RE: 10 CFR 71.95(a)(3) report for CoC number USA/9187/B(U)-96

QSA Global, Inc. is making a report under 10 CFR 71.95(a)(3) concerning the Model 865 Type B packages (CoC 9187).

SOURCE ACTUATOR ASSEMBLY

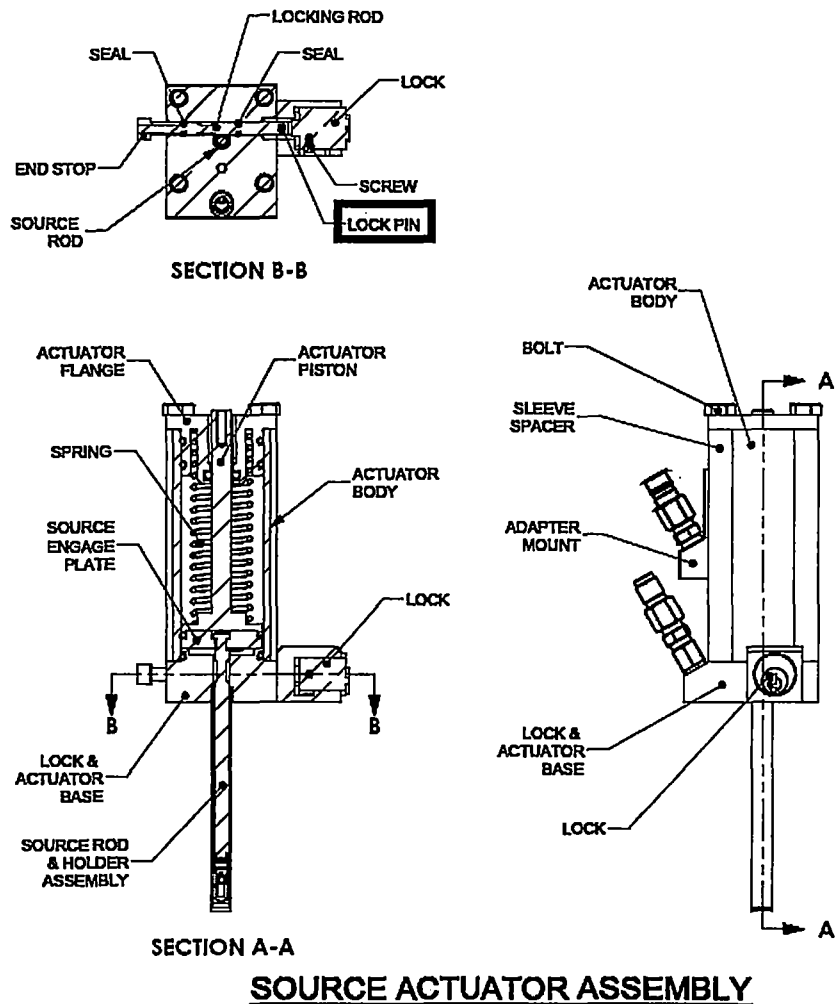
The exploded view of the actuator assembly shown on sheet 4 of drawing R86590 Revision J does not show the pin connecting the plunger lock to the locking rod. The pin has always been present in all Model 865 transport packages and all Model 865 Type-B test specimens. The pin is needed to unlock the source from the shield, but is NOT needed to lock the source into the fully shielded position in the package. See figure below for pin location:
